**Subject** ▶ Modification of Clutch Cum and its related parts

**For Models** ▶ 6220D,6221D(Cordless Driver Drill)

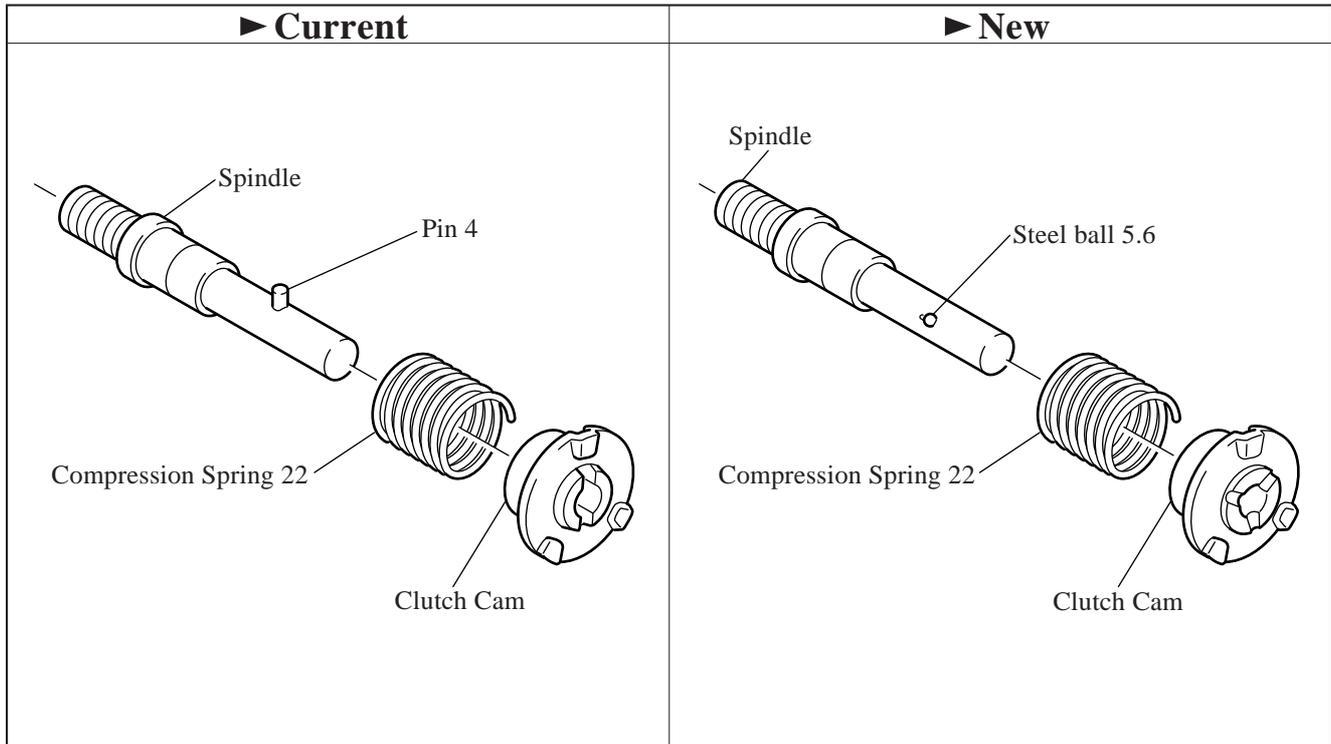
**Description** ▶ As illustrated below, the structure of parts of Clutch has been changed to smooth the action of Clutch, with the intention of stabilizing its torque.

- ; Change Pin 4 to Steel Ball 5.6.
- ; Change on Clutch Cam according to above change.
- ; Change Compression Spring for secure Clutch Cam movement by higher compression

Item No.	Current part	Q'ty	I/C	New part	Q'ty	Note
25	Clutch Cam 223101-9	1		Clutch Cam 223115-8	1	Interchangeable as a set ↑ ↓
21	Spindle 322690-2	1		Spindle 322880-7	1	
24	Pin 4 256054-7	1		Steel Ball 5.6 216011-7	3	
10	Compression Spring 22 233043-9	1		Compression Spring 22 233061-7	1
